Access Compliance Report

Public Rights-of-Way

(Curb Ramps)

Intersection ID: 30318	Main Street: CANNONBALL_DR	Cross Street: SHINKANSEN_DR	Location: W
ADA ID: 3659FCF8334B	Ramp Type: PerpDiag	Initial Pass/Fail: Fail	Overall Compliance: No
		Severity Score: 25

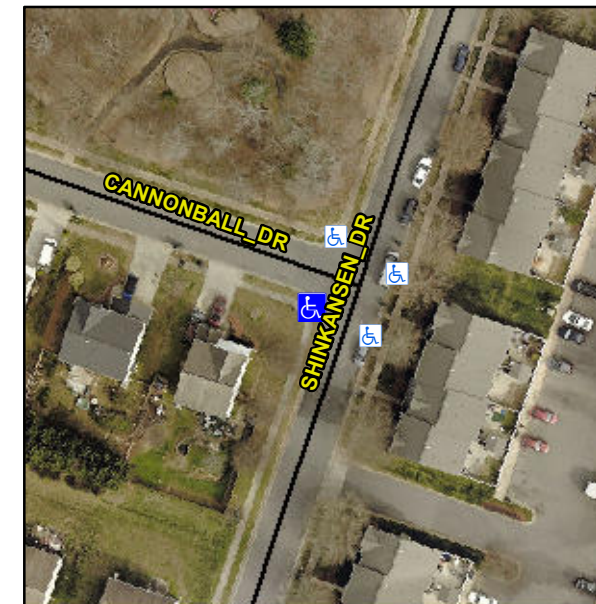
Not Found, R304.5.3

Compliance	Description	Data	Compliance	Description	Data
N/A	Ramp Length (in)	48.0	Yes	Ramp Slope (%)	7.5
Yes	Ramp Width (in)	54.5	No	Ramp XSlope (%)	7.2
N/A	Flare Type LT	N/A	N/A	Flare Type RT	N/A
N/A	Flare Slope LT (%)	N/A	N/A	Flare Slope RT (%)	N/A
N/A	Flare Traversable LT?	N/A	N/A	Flare Traversable RT?	N/A
N/A	Landing Length (in)	N/A	N/A	DWS Provided?	N/A
N/A	Landing Width (in)	N/A	N/A	DWS Contrast?	N/A
N/A	Landing Slope (%)	N/A	N/A	DWS Length (in)	N/A
N/A	Landing X Slope (%)	N/A	N/A	DWS Full Width?	N/A
N/A	Landing Curb? (Y/N)	N/A	N/A	DWS Offset (in)	N/A
N/A	Shared Landing?	N/A			
N/A	Gutter Ponding?	N/A	N/A	Gutter Slope (%)	N/A
N/A	Gutter Lip Ht (in)	N/A	N/A	Gutter X Slope (%)	N/A
N/A	Painted X Walk1?	No	N/A	Painted X Walk2?	No
	X Walk 1 Direction	To S		X Walk 2 Direction	To N
N/A	X Walk 1 Width (in)	N/A	N/A	X Walk 2 Width (in)	N/A
	X Walk 1 Slope (%)	5.3		X Walk 2 Slope (%)	2.0
	X Walk 1 X Slope (%)	3.1		X Walk 2 X Slope (%)	6.3

Remove & Replace Curb Ramp With Two New Directional Ramps or Equivalent.
